Access Compliance Report Public Rights-of-Way (Curb Ramps)

Main Street: SNAPDRAGON_ST Cross Street: WINDMILL_AVE Location: SW

ADA ID: RPRK211029143529 Ramp Type: Type 4 - Parallel Initial Pass/Fail: Fail Overall Compliance: No Severity Score: 15

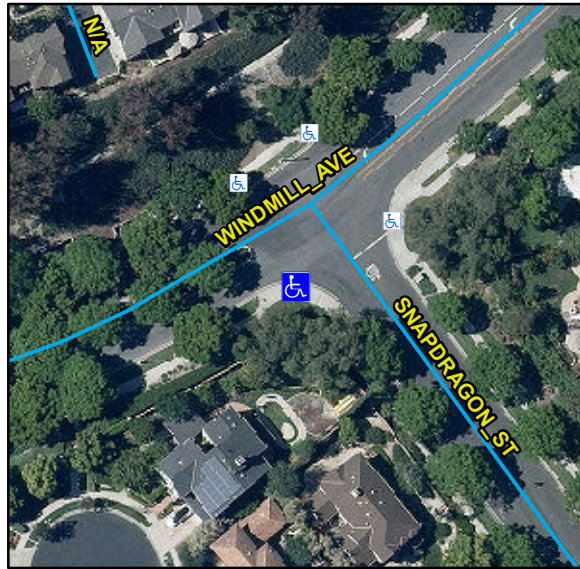
Compliance	Description	Data	Compliance	Description	Data
N/A	Ramp Length LT (in)	135	N/A	Ramp Length RT (in)	94
Yes	Ramp Width LT (in)	90	Yes	Ramp Width RT (in)	90
Yes	Ramp Run Slope LT (%)	2.9	Yes	Ramp Run Slope RT (%)	2.6
No	Ramp Cross Slope LT (%)	5.4	No	Ramp Cross Slope RT (%)	4.4
N/A	Landing Present	N/A	N/A	DWS Provided	N/A
N/A	Landing Length (in)	N/A	N/A	DWS Contrast	N/A
N/A	Landing Width (in)	N/A	N/A	DWS Length (in)	N/A
N/A	Landing Run Slope (%)	N/A	N/A	DWS Full Width	N/A
N/A	Landing Cross Slope (%)	N/A		DWS Offset Type	N/A
N/A	Landing Movement Obstructed?	N/A	N/A	DWS Offset Left (in)	N/A
	Landing Movement Type	N/A	N/A	DWS Offset Right (in)	N/A
N/A	Landing Shared	N/A			
N/A	Clear Space	Yes			
N/A	Clear Space To Crosswalk (in)	N/A			
N/A	Marked Crosswalk 1	No	N/A	Marked Crosswalk 2	No
	Crossing 1 Direction	E		Crossing 2 Direction	N
	Marked Crosswalk 1 Width (in)	N/A		Marked Crosswalk 2 Width (in)	N/A

Remove & Replace Curb Ramp With Two New Directional Ramps or Equivalent.
